Re: Chevron Facility # 9-8139

Address: 16304 Foothill Boulevard, San Leandro, California

Re: **Response to Technical Comments**
Chevron Service Station 9-8139
16304 Foothill Boulevard
San Leandro, California

figure 2
 SITE PLAN
 CHEVRON SERVICE STATION 9-8139
 16304 FOOTHILL BOULEVARD
 San Leandro, California

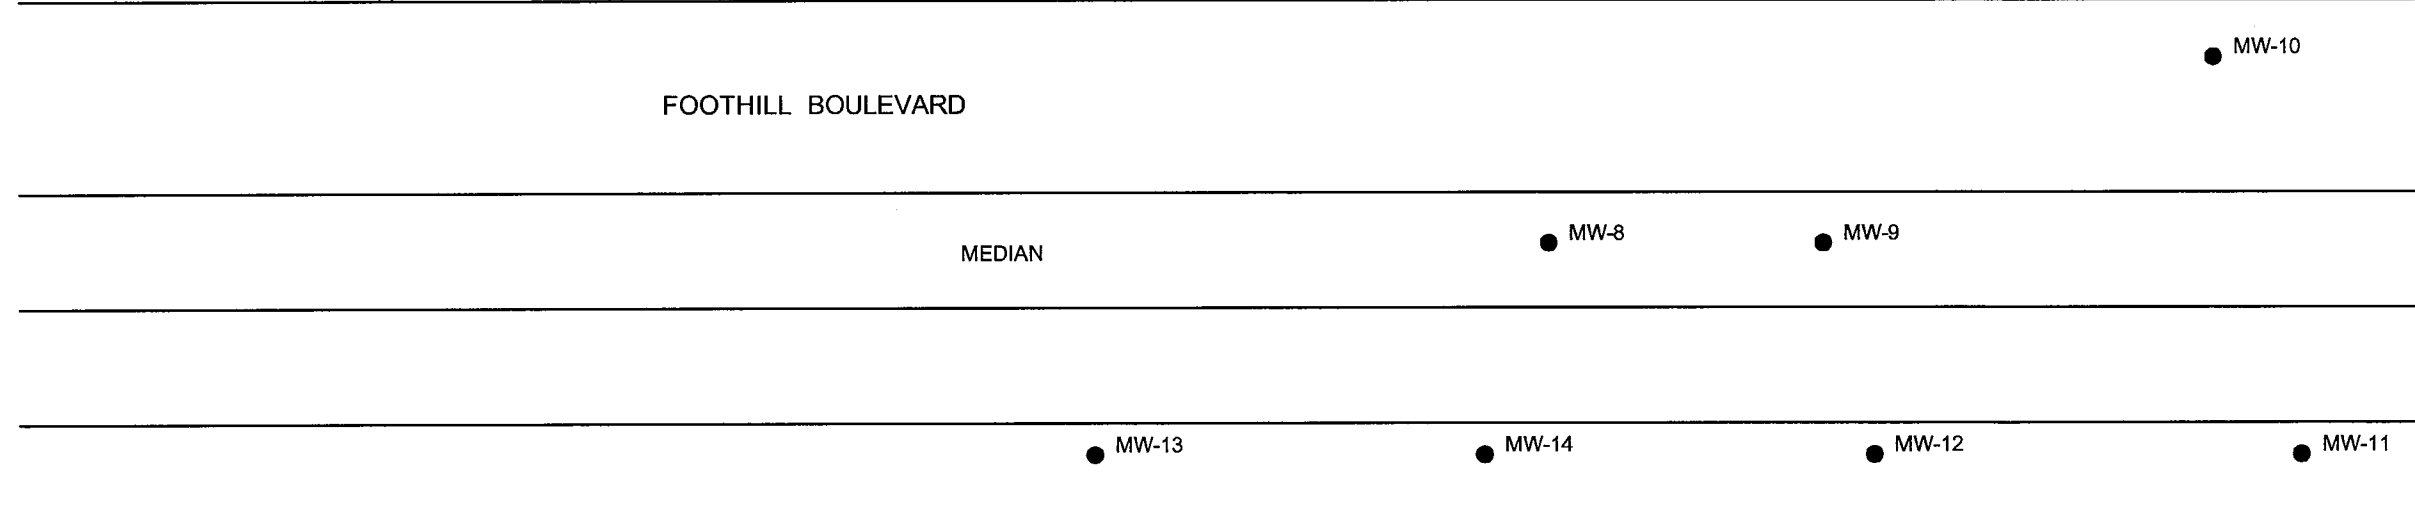
We are concerned with monitoring the effectiveness of the surfactant extraction pilot test by sampling the same treated wells. Nothing is proposed to determine the extent of the application or treatment. We suggest that minimally, E-3 be monitored for the presence of surfactant as well as considering installing a monitoring well immediately down-gradient of the proposed extraction well.

CRA has decided to cancel the surfactant extraction pilot test and will evaluate site conditions based on the results of the subsurface investigation.
